ADDENDUM #4

INVITATION FOR BID #16-105

SUPPLY AND INSTALL EXERCISE EQUIPMENT AT AUBURNDALE COVE

THIS ADDENDUM IS TO: **Correct the Project Manual as follows:**

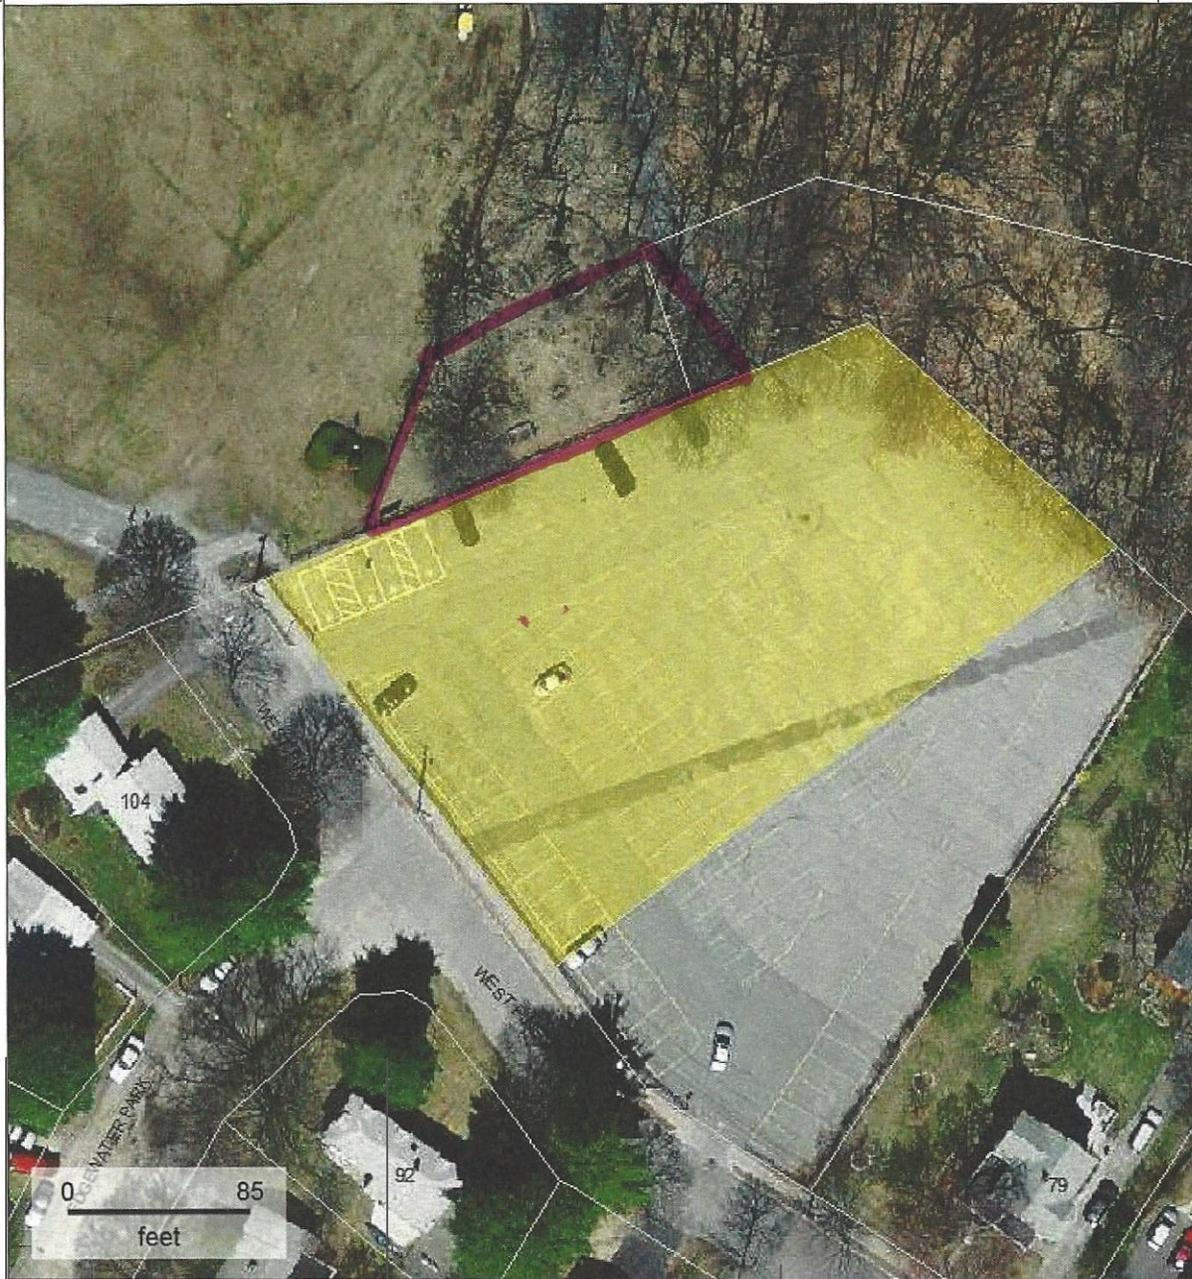
Q2. I also don't see any drawings for this project. Looking for dimensions of site, is all the equipment going in one area?

Q3. Are there paths to travel from piece to piece that would require wood carpet?

A2. Dimension, diagram and aerial of site attached.

A3. There is no wood carpet specified in specs. The entire area will have timber border with a compact stone dust finish in the entire area. See drawings.
